MODIFICATION No.: 23433K3130

TITLE: AIR CONDITIONING - CARGO COMPARTMENT HEATING - MODIFY THE HEAT

CONTROLLER (1HC) FOR FWD CARGO COMPARTMENT

SERVICE BULLETIN No.: A320-21-1070

Location of FWD Cargo Heat Controller 1HC Figure 1

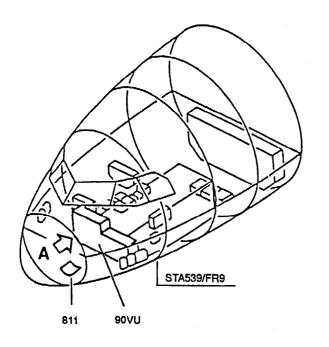
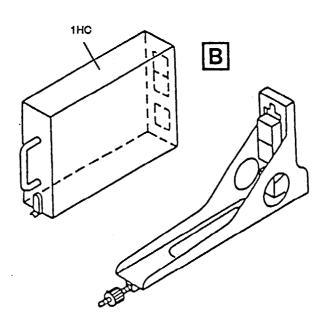
- (1) Remove the cargo heat controller (1HC), PN 600611-00-505 in accordance with the AMM 21-43-34, P. Block 401.
- (2) Modify the cargo heat controller (1HC) as per Para. 2.F.
- (3) Install the modified FWD cargo heat controller (1HC), PN 600611-00-506 in accordance with the AMM 21-43-34, P. Block 401.
